Economic Commission for Europe
Inland Transport Committee
World Forum for Harmonization of Vehicle Regulations
Working Party on Passive Safety
Seventy-third session
 Geneva, 15–19 May 2023

**Report of the Working Party on Passive Safety
 on its seventy-third session**
Contents

"Annex 5 – Appendix 2

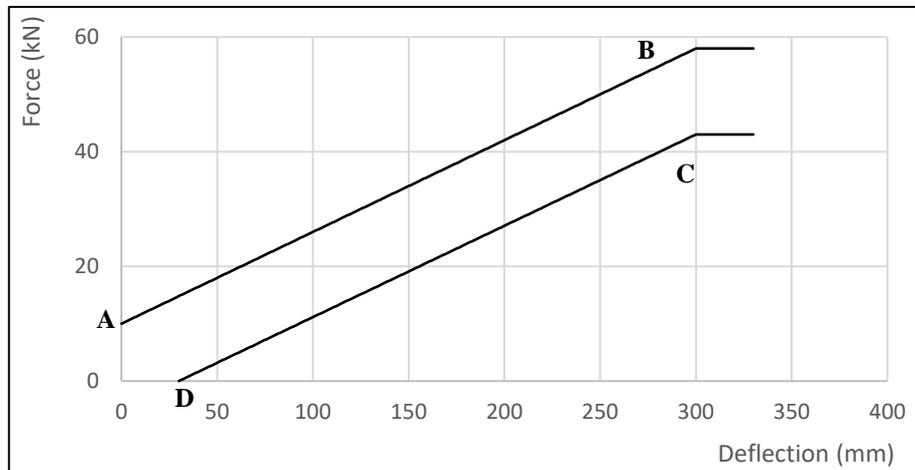
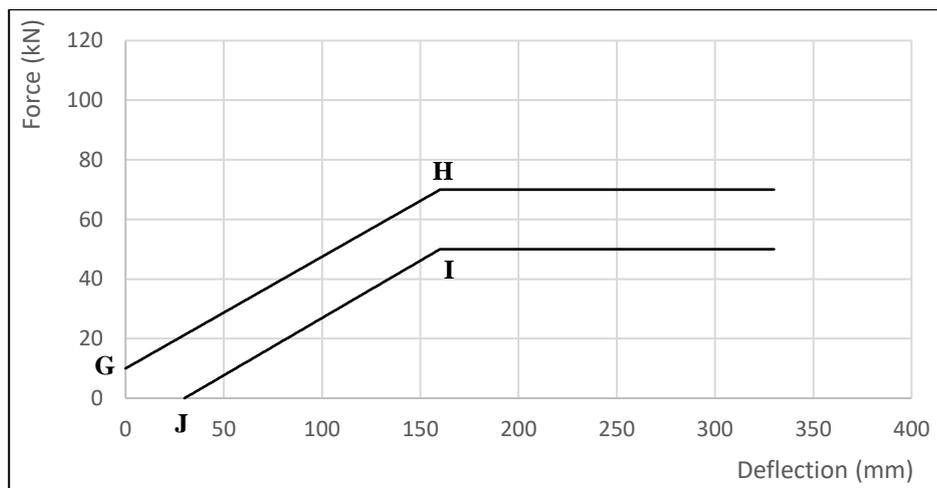
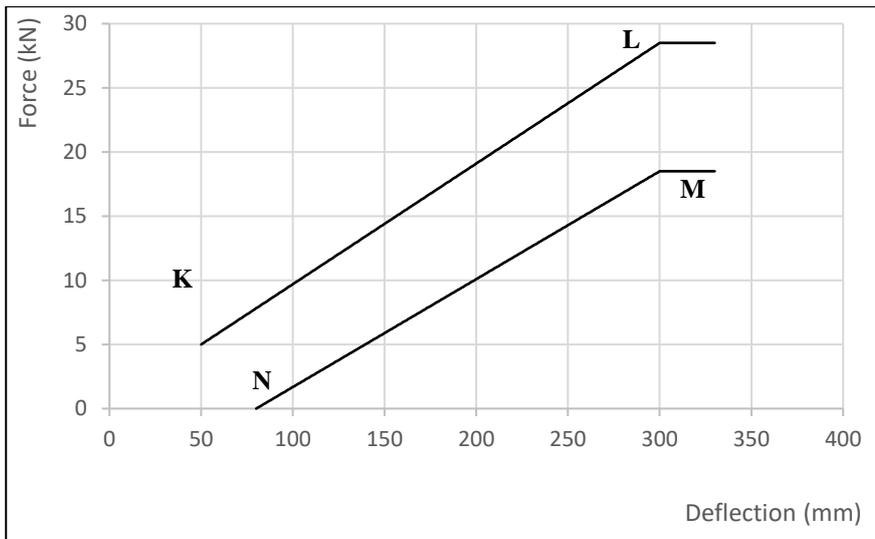
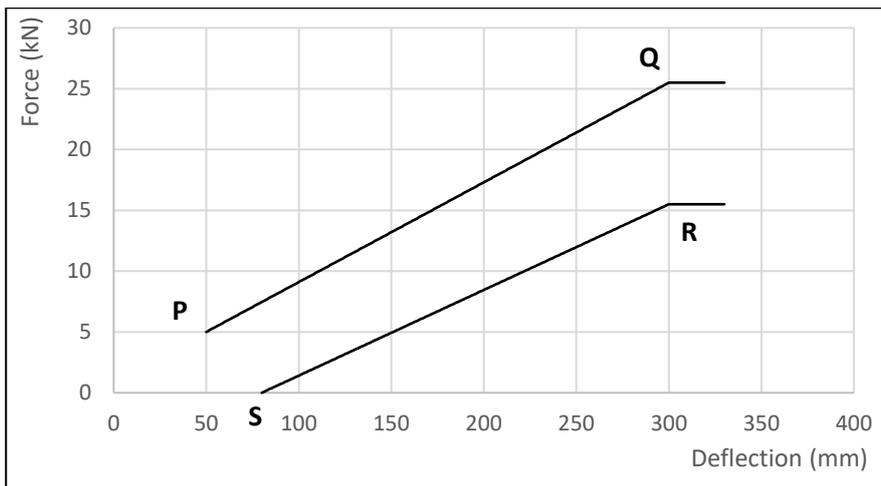
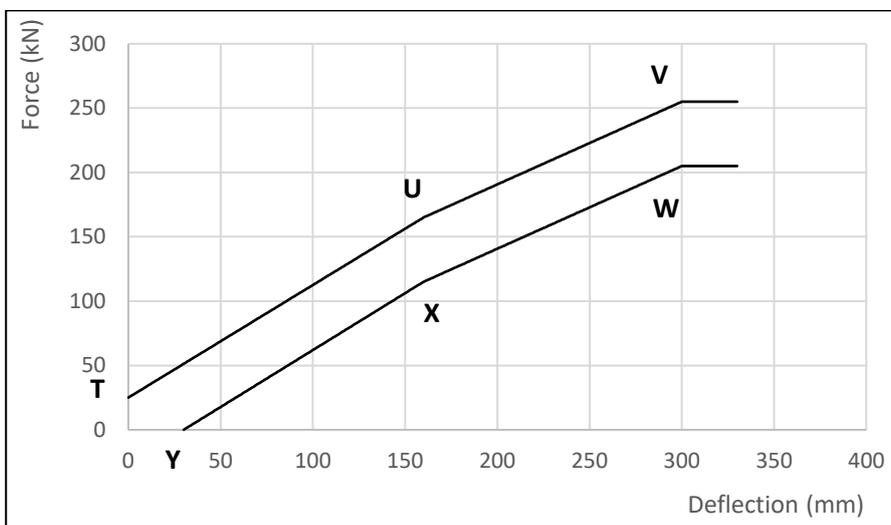
24. The expert from France introduced GRSP-73-44 and GRSP-73-45, to amend respectively the 04 and 05 series of amendments, to clarify the figures of Annex 5, Appendix 2 and to reintroduce legends which had been removed from the 02 Series of Amendments to the UN Regulation. GRSP adopted both proposals, as reproduced in annex VI, and requested the secretariat to submit GRSP-73-44 as draft Supplement 3 to the 04 Series of amendments, and GRSP-73-45 as draft Supplement 4 to the 05 Series of Amendments to UN Regulation No. 95 for consideration and vote at the November 2023 sessions of WP.29 and AC.1.

Figure 3 (j)
Test 1

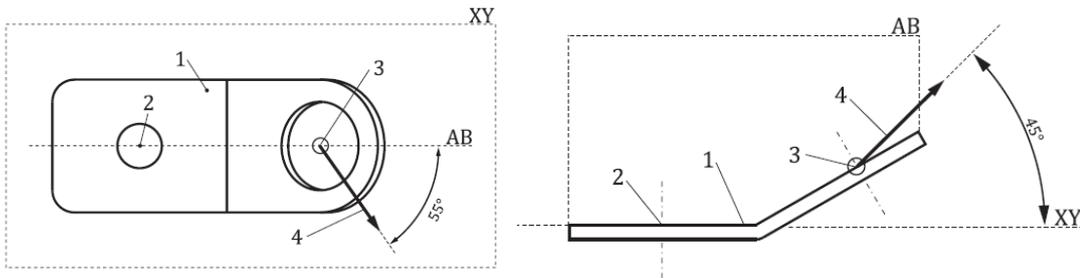
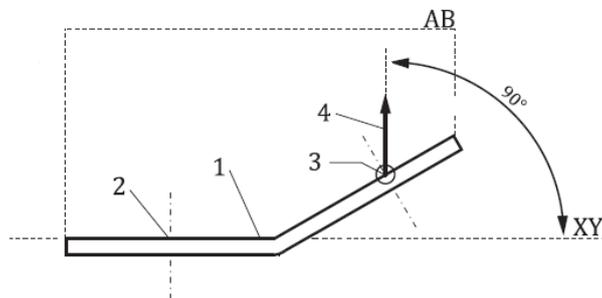
Two tests **shall be** performed; See figure 3 (j) and 3 (k)

(a) the force shall be applied ..., measured in plane AB; **rotation around the anchorage point to vehicle (2) shall be prevented.**

See figure 3 (j);
